IN THE DRAWINGS

REMARKS

Fig. A3
(DE 2805438)

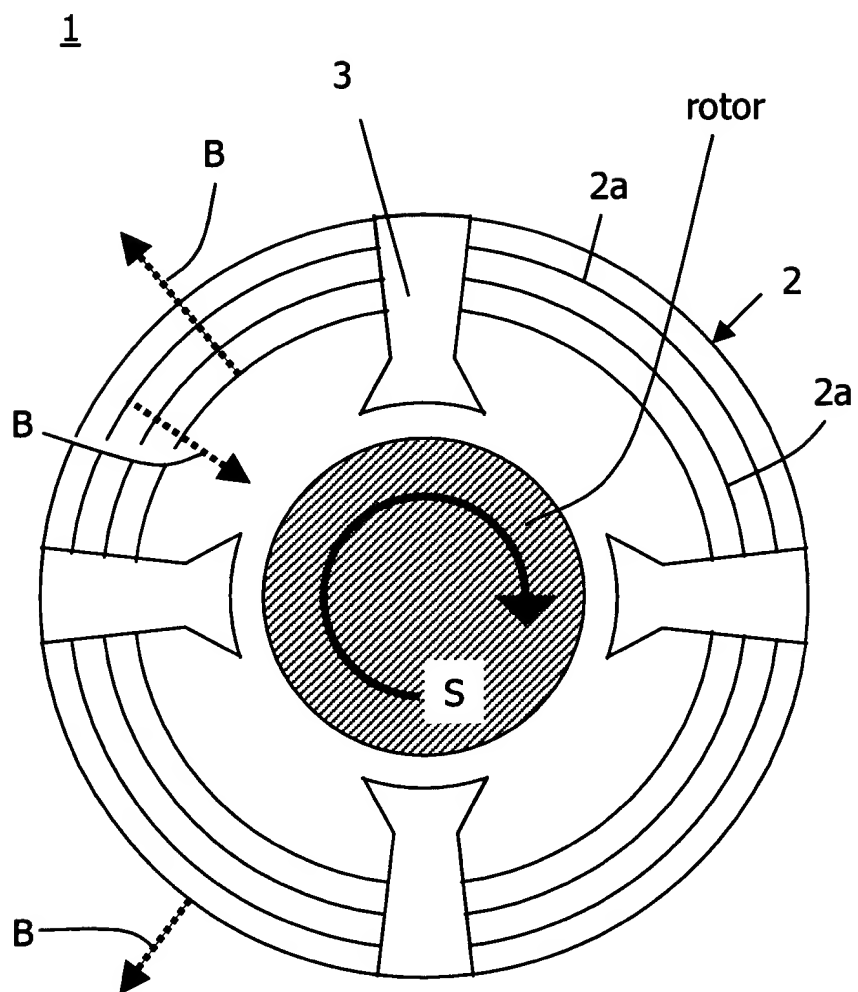
The Examiner's attention is respectfully drawn to Fig. A5, submitted herewith, which is adapted from Fig. A3 as submitted in connection with Applicants' appeal brief dated November 6, 2002. Fig. A5 depicts the magnetic structure provided in the Figure of the '438 patent. For greater clarity, the structure is drawn in end-on, cross-sectional view. Generally stated, the structure comprises four back-iron sections 2 and four pole shoe sections 3. Applicants agree that each of the *segments* that comprise the '438 magnetic structure has plural surfaces. In particular, applicants agree that each section 2 and each section 3, taken as a whole, has a radially inward-facing surface and a radially outward-facing surface. For convenience these surfaces are labeled IS2 and OS2 for sections 2 and IS3 and OS3 for sections 3 in Fig. A5.

However, applicants maintain that the structure of shoe sections 3, as oriented and assembled in a stator in accordance with the Figure of '438, fails to satisfy the configurational requirement of claim 1 and that the Examiner's conclusion otherwise is based on an incorrect reading of the claim. In the portion of the rejection of October 10, 2003 quoted hereinabove, the phrase emphasized speaks of the surfaces of the *segment*, not the surfaces of the *strips*, as delineated by Applicants' claims. Thus, the surfaces labeled IS3 and OS3, while admittedly surfaces of *segments* 3, are not the surfaces of any of the *strips* comprised in the segments 3. Applicants' claims expressly require perpendicular orientation of the surfaces of strip, not surfaces of segments.

Lines normal to surfaces IS3 and OS3 at substantially any point thereof are admittedly perpendicular to the axis of rotation of the rotor. However, shoe segments 3 comprise a plurality of individual layers of (crystalline) magnetic metal strip that are stacked in registry. Each of the layers in the Fig. A5 configuration is identical in shape and has a top surface and a bottom surface. Lines normal to the layers comprised in segments 3 at any point thereon are submitted to be *parallel* to the rotation axis, i.e., perpendicular to the page of Fig. A5, and not *perpendicular* to the rotation axis, as required by claim 1.
